NISSAN Motor Genuine
2DIN HDD Navigation

Model **UQY7813**
(N# 25915 ZQ39A)
(MODEL No. NAU-3221KUS-V)

ORIGINAL SERVICE MANUAL

The original model of UQY7813/4/5/6,UQY7823/4/5/6 is UQY6102. This additional service manual is designed to be used together with the service manual of UQY6102.

Drawing-30

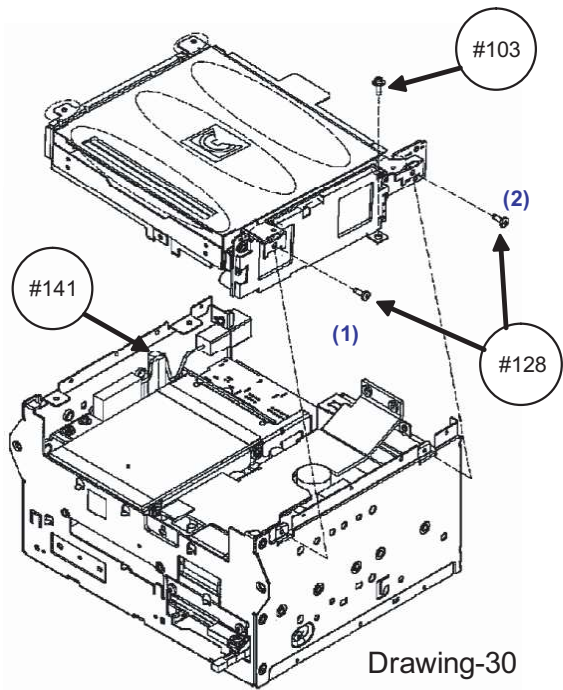
Please confirm it about the additional part (#141) in the following
ASSEMBLY DRAWING and ASSEMBLY PROCEDURE.

PROCEDURE	NOTICE
3.Stick the(#141)ANT sheet on the processed AUDIO PWB ASSY (Drawing-30) and lay out GPS-ANT cable.	※Through the SHEET ANT upper part. (Drawing-24)
